Form 3160-5
(June 2019)UNITED STATES
DEPARTMENT OF THE INTERIOR
BUREAU OF LAND MANAGEMENTFORM APPROVED
OMB No. 1004-0137
Expires: October 31, 2021**SUNDRY NOTICES AND REPORTS ON WELLS**
Do not use this form for proposals to drill or to re-enter an abandoned well. Use Form 3160-3 (APD) for such proposals.

8. Well Name and No. GALLEON 21 FED/303H

EOG respectfully requests an amendment to our approved APD for this well to reflect the following changes:

Galleon 21 Fed 701H (FKA 303H) API #: 30-025-47274

Figure 3: Back Yard Rig Up

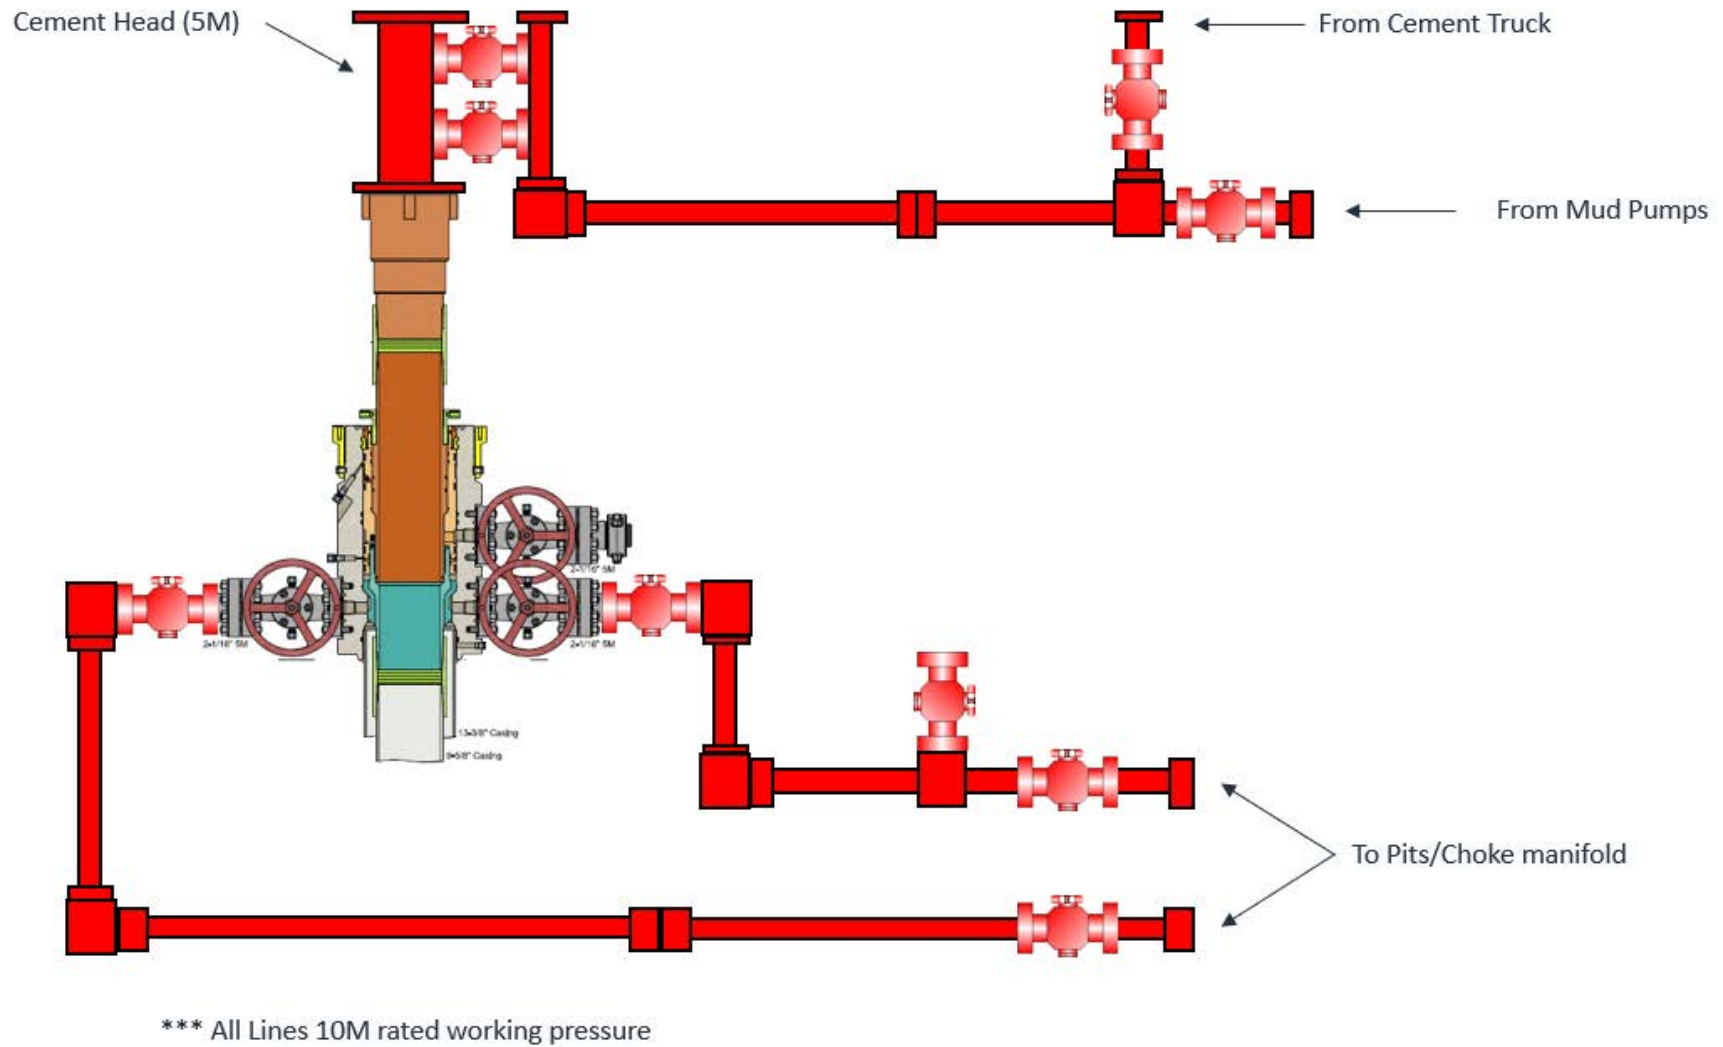
- c. Return line schematics can be seen in Figure 3.
10. Remove TA Plug from the casing.
11. Install offline cement tool.
 - a. Current offline cement tool schematics can be seen in Figure 1 (Cameron) and Figure 2 (Cactus).
